## **Service Kit**

Title: Bell 429 Air Conditioner Condenser Blower Motor Upgrade

**Applicability:** Bell Helicopter Model 429 Equipped with the Air Comm Corporation

**Reference:** FAA / STC # SR00693DE, Bell Helicopter 429 Air Conditioning System

Figure 1. Existing blower on the condenser assembly

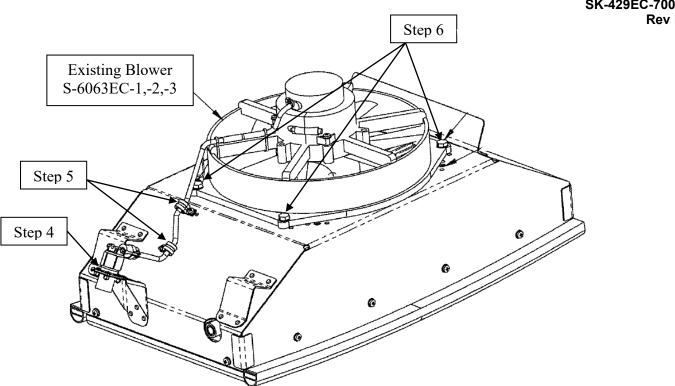
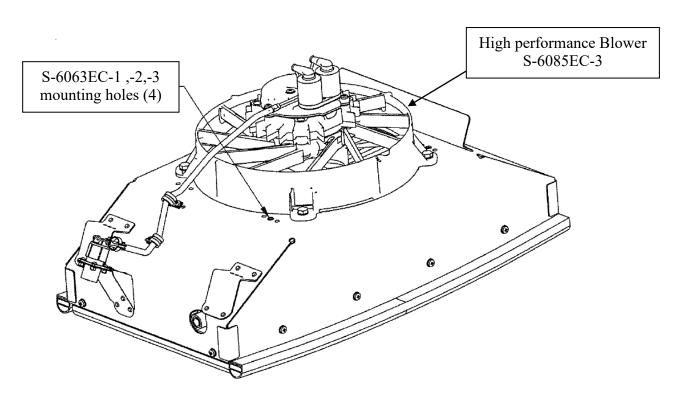
This document provides for an air conditioning system improvement for aircraft operating in extreme environments by the replacement of the existing condenser blower with a blower that provides a higher condenser performance. This document also provides information for modifying the supporting electrical wiring to accommodate the slightly higher power draw of the new blower.

- 1. Disconnect, cap, and stow any air conditioning plumbing tubes or hoses that interfere with the removal of the condenser fan.
- 2. Remove the cabin evaporators. Refer to the Instructions for Continued Airworthiness (ICA) 429EC-200M-1 for instructions.
- 3. Disconnect the blower electrical connector (see Fig. 1).
- Remove 4 each MS21044N04 nuts, 8each NAS1149DN432J washers, & 4each MS35206-215 screws from the electrical plug and remove the plug from its retaining bracket.
- 5. Remove 2 each MS27039-0808 screws, 2 each NAS1149FN832P Washers, & 2 each MS21919WDG6 clamps holding the blower wires to the condenser housing.
- 6. Remove 4 each AN5-7A bolts holding the S-6063EC-1,-2,-3 condenser blower assembly.
- 7. Remove the S-6063EC-1,-2,-3 condenser blower assembly.
- 8. Fill the 4 exposed blower mounting holes in the condenser shroud with RTV 100 series black silicone adhesive.

- 1. If the S-6085EC-3 condenser blower assembly mounting holes are not pre-existing in the condenser housing, locate the new mounting holes using the new S-6085EC-3 condenser blower assembly as a template by centering it over the existing blower opening in the condenser housing and transferring the holes.
  - a. Install 4 each MS21059L5 nutplates using 8 each MS20426AD4-5 Rivets.
- 2. Remove any RTV from the mounting holes if present.
- 3. Fit the condenser blower into place.

- 4. Do not re-install the previously removed 4 each AN5-7A bolts. Follow the instructions in document SB 429-206 to install 4 each ES39019-1 Locking Fasteners in the 4 mounting locations to secure the blower in place.

Figure 3. Circuit Breaker panel and Air Conditioning Relay Panel Box

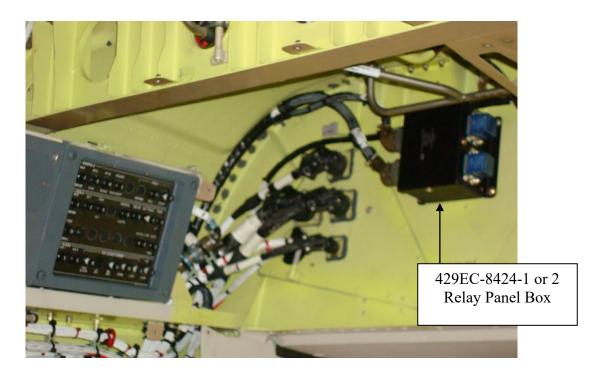
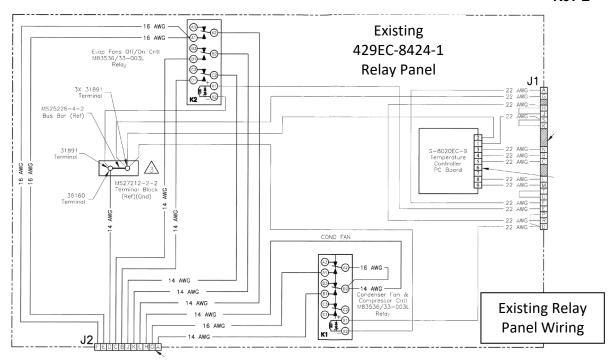
1. Remove 1 each MS26574-20 20 AMP circuit breaker located at the "COND" position in the RH Non Essential Bus.

1. Install 1 each MS26574-25 25 AMP circuit breaker at the "COND" location in the RH Non-Essential Bus.

Figure 5. 429EC-8424EC-1 Relay Panel Box Wiring, existing and modified

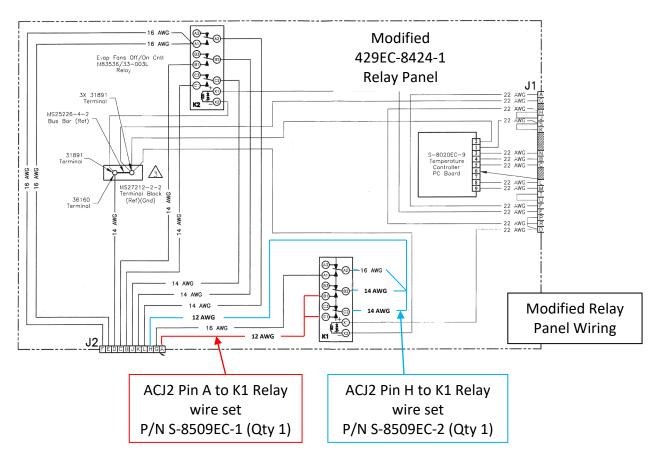
- 1. Locate the 429EC-8424-1 Relay Panel Box. Disconnect the external connections and remove the box.
- 2. Referring to electrical schematic Figure 5, remove wire between Pin A at the ACJ2 receptacle and pin B1 at the K1 relay.
- 3. Remove wire between Pin H at the ACJ2 receptacle and pins A2 & B2 at the K1 relay.

- 1. Install 1each supplied S-8509EC-1 wire set between Pin A at the ACJ2 receptacle and pins B1 & C1 at the K1 relay.
- 2. Install 1 each supplied S-8509EC-2 wire set between Pin H at the ACJ2 receptacle and pins A2, B2 & C2 at the K1 relay. Note that the smaller, 16 ga wire must be inserted into position A2 on K1 and the 14 ga wires must be inserted into B2 & C2.
- 3. Locate the existing part marking and with indelible ink add next to it part marking "SK-429EC-7000" to indicate the upgrade to the relay panel box.
- 4. Replace the 429EC-8424-1 Relay Panel Box and re-mate the electrical connections.
- 5. Apply aircraft electrical power and verify operation of the condenser blower.

Figure 6. 429EC-8424EC-2 Relay Panel Box Wiring, existing and modified

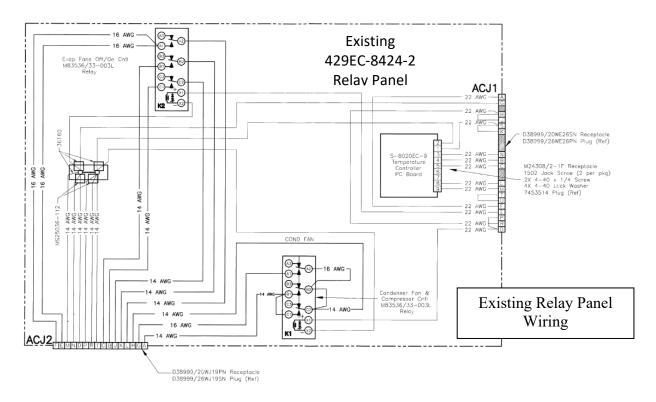
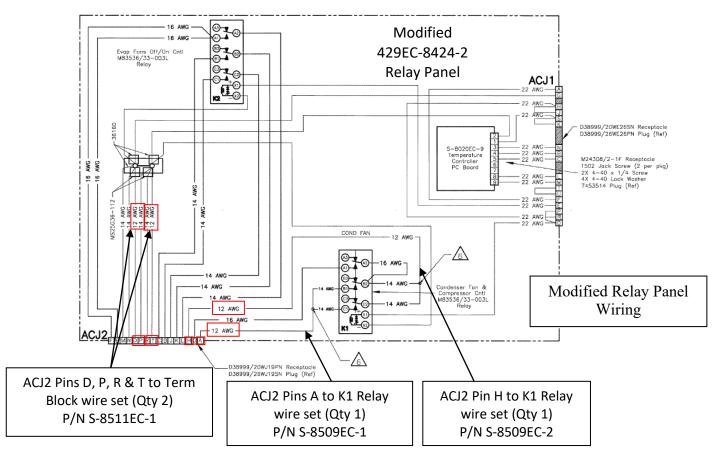
- 1. Locate the 429EC-8424-2 Relay Panel Box. Disconnect the external connections and remove the box.
- 2. Referring to electrical schematic Figure 5, remove wire between Pin A at the ACJ2 receptacle and pins B1 & C1 at the K1 relay.
- 3. Remove wire between Pin H at the ACJ2 receptacle and pins B2 & C2 at the K1 relay.
- 4. Remove wire set from ACJ2 pins D & P and the terminal block.
- 5. Remove wire set from ACJ2 pins R & T and the terminal block.

- 1. Install 1 each supplied S-8509EC-1 wire set between Pin A at the ACJ2 receptacle and pins B1 & C1 at the K1 relay.
- 2. Install 1 each supplied S-8509EC-1 wire set between Pin H at the ACJ2 receptacle and pins B2 & C2 at the K1 relay.
- 3. Install 1 each supplied S-8511EC-1 wire set from ACJ2 pins D & P receptacle and the terminal block. Note that pin D receives the 12 ga. wire, and pin P receives the 14 ga. wire.
- 4. Install 1 each supplied S-8511EC-1 wire set from ACJ2 pins R & T receptacle and the terminal block. Note that pin T receives the 12 ga. wire, and pin R receives the 14 ga. wire.
- 5. Locate the existing part marking and with indelible ink add next to it part marking "SK-429EC-7000" to indicate the upgrade to the relay panel box.
